| Well Name: CO 34 27 FEDERAL COM | Well Location: T25S / R32E / SEC 3 / LOT 1 / 32.164948 / -103.655722 | County or Parish/State: LEA / NM |
| Well Number: 635H | Type of Well: OIL WELL | Allottee or Tribe Name: |

Notice of Intent

Type of Action: APD Change

ACREAGE DEDICATION PLATS

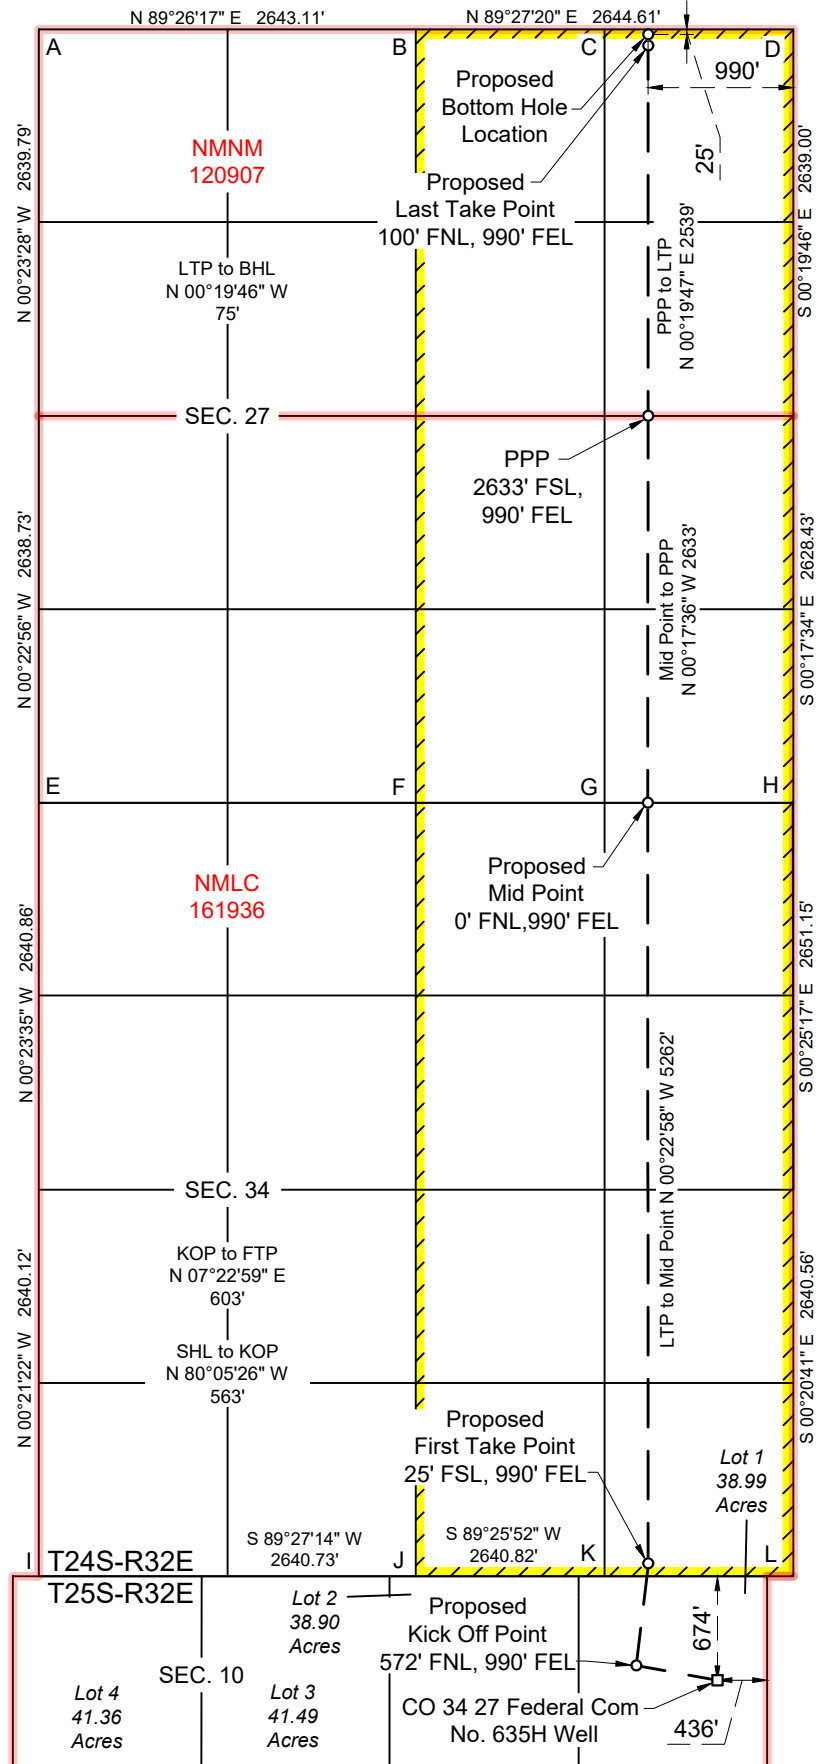
Chevron U.S.A. Inc. requests an update to the C102. The original surveyor (Fenstermaker) provided incorrect footages, Property Code and Order# on the C102 and the current surveyor (Holland) has revised the C102 to show the correct information. Please refer to the corrected C102 for CO 34 27 FED COM #635H.

Changes requested per NMOCD on C102

OLD SHL: UL: A SECT 3 T-25S R-32E 527' FNL & 674' FEL

NEW SHL:UL: A SECT 3 T-25S R-32E 674' FNL & 436' FEL
